**To:** Loch Lomond & The Trossachs National Park Authority  
**From:** Peter Brett Associates  
**Date:** 28/03/19  
**Subject:** West Riverside Parking Strategy

We are in receipt of a request from the Planning Authority to provide a response to the following comments in relation to traffic and parking based on the West Riverside & Woodbank House, Balloch, Transport Assessment:

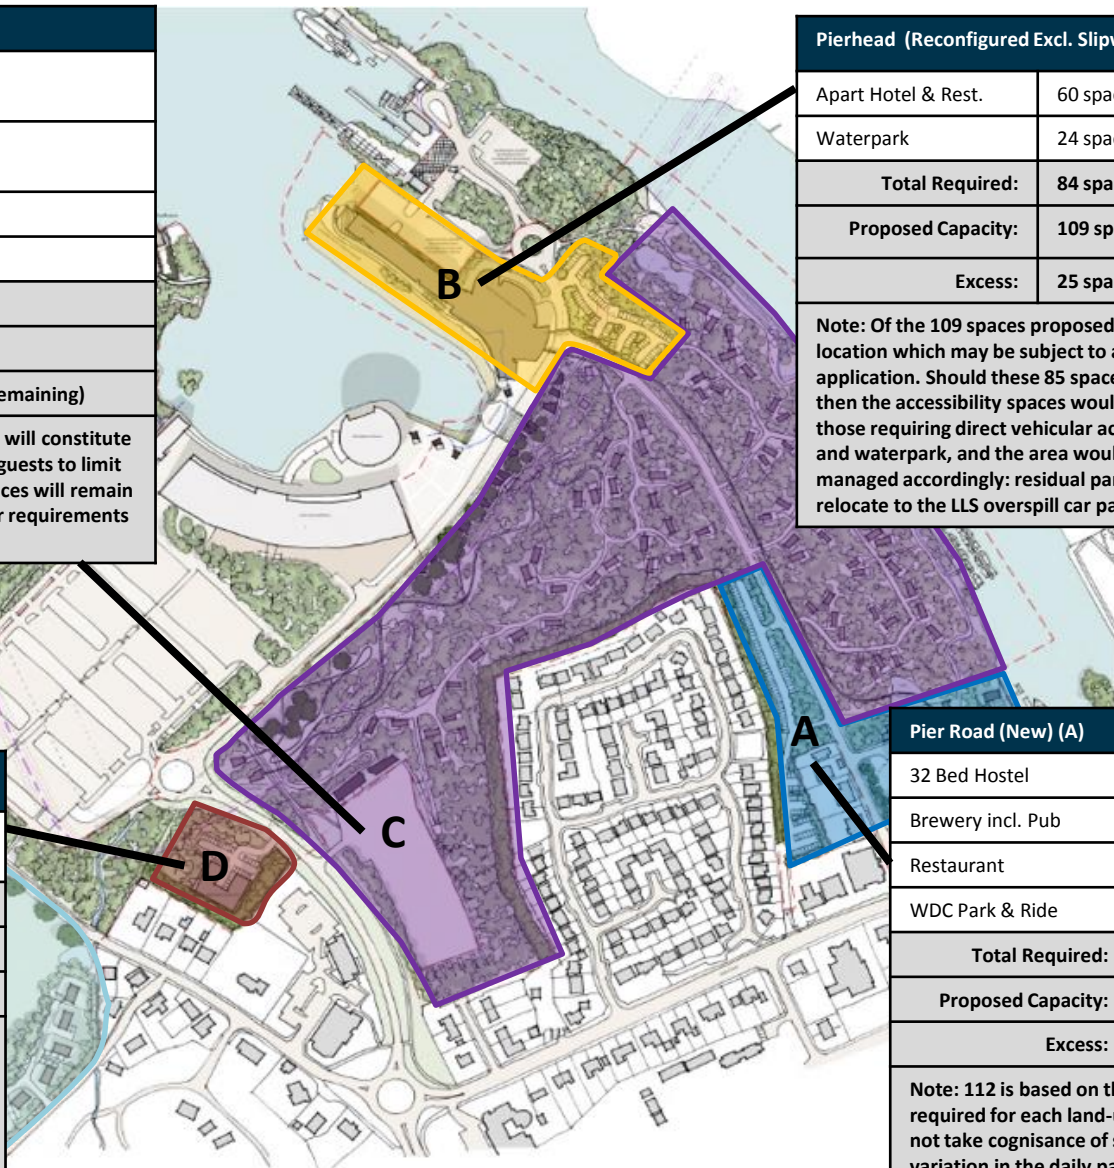
***Paragraph 3.2.25 of the Planning Statement confirms that a total of 330 spaces will be provided across the site (excluding Woodbank House) – this is 97 net additional spaces discounting the existing 233 spaces that currently exist at Balloch Pier and the Old Station. Please confirm if the proposed provision includes the 44 displaced Park and Ride Spaces requested by WDC or consider the potential impacts of the loss of existing parking associated with the Slipway or Maid of the Loch? Can you please provide a parking plan showing the numbers of parking spaces proposed in each area and distribution across the site (to ensure that a sufficient number of parking spaces are provided in the locations it will be required to service the uses). Please also demonstrate that the areas shown for parking have capacity for the numbers proposed (to ensure we can be satisfied that no additional parking within the site will be required).***

- 1.1.6 The level of parking provision for the proposed land uses and their proposed locations, through provision of a parking strategy (as appended to this note) demonstrates the proposed parking spaces and distribution across the site.
- 1.1.7 Appendix 1 includes a graphical representation of the West Riverside Proposed Parking Strategy and the Woodbank Site Parking Strategy.

LLS Overspill Car Park (C) – 359 Spaces Existing	
Woodland Lodges Riverfront (43)	65 spaces
Woodland Lodges Drumkinnon (32)	48 space
Boathouse Accommodation	1 space
Staff & Servicing (residual)	11 spaces*
<b>Total Required:</b>	<b>125 spaces</b>
<b>Proposed Capacity</b>	<b>125 spaces</b>
<b>Excess:</b>	<b>234 spaces (remaining)</b>
<p>Note: Some of the existing overspill parking area will constitute long-stay overnight parking for accommodation guests to limit the volume of traffic through the site. Ample spaces will remain within the overspill car park for events and other requirements as appropriate to the order of 234 spaces.</p>

Pierhead (Reconfigured Excl. Slipway Ops) (B)	
Apart Hotel & Rest.	60 spaces
Waterpark	24 spaces
<b>Total Required:</b>	<b>84 spaces</b>
<b>Proposed Capacity:</b>	<b>109 spaces (incl. 24 accessible)</b>
<b>Excess:</b>	<b>25 spaces</b>
<p>Note: Of the 109 spaces proposed, 85 are sited on a location which may be subject to a future planning application. Should these 85 spaces require to relocate, then the accessibility spaces would remain and cater for those requiring direct vehicular access to the apart hotel and waterpark, and the area would be reconfigured/ managed accordingly: residual parking demand would relocate to the LLS overspill car park.</p>

Staff and Servicing Area (D)	
Staff & Servicing 900sqm	45 spaces
<b>Total Required:</b>	<b>45 spaces</b>
<b>Proposed Capacity:</b>	<b>34</b>
<b>Excess:</b>	<b>-11* spaces</b>
<p>Note: Due to shift patterns it is anticipated that 34 spaces located at the staff and service area will be ample, however, residual demand or ancillary parking could be accommodated in the LLS overspill car park as appropriate. The intention is to encourage employees to walk and cycle to work as far as reasonably practicable.</p>

Pier Road (New) (A)	
32 Bed Hostel	8 spaces
Brewery incl. Pub	30 spaces
Restaurant	30 spaces
WDC Park & Ride	44 spaces
<b>Total Required:</b>	<b>112 spaces</b>
<b>Proposed Capacity:</b>	<b>109 spaces</b>
<b>Excess:</b>	<b>-3</b>
<p>Note: 112 is based on the number of spaces required for each land-use in isolation and does not take cognisance of shared uses of spaces nor variation in the daily parking demand profile. The proposed capacity of 109 spaces is considered ample across the development uses.</p>

Woodbank Site (E)	
6 Private Houses (2 beds)	12 spaces
15 Private Flats (7 x 1 bed, 8 x 2 bed)	23 spaces
19 Woodland Lodges	38 spaces
16 Woodland Lodges	32 spaces
15 Woodland Bothies	23 spaces
6 Holiday Apartments	11 spaces
<b>Total Required:</b>	<b>139 spaces</b>
<b>Proposed Capacity:</b>	<b>139 spaces</b>
<b>Excess:</b>	<b>0 spaces</b>
<b>Note: As a new site, parking provision will be provided in compliance with relevant parking standards and can be accommodated within the site extents.</b>
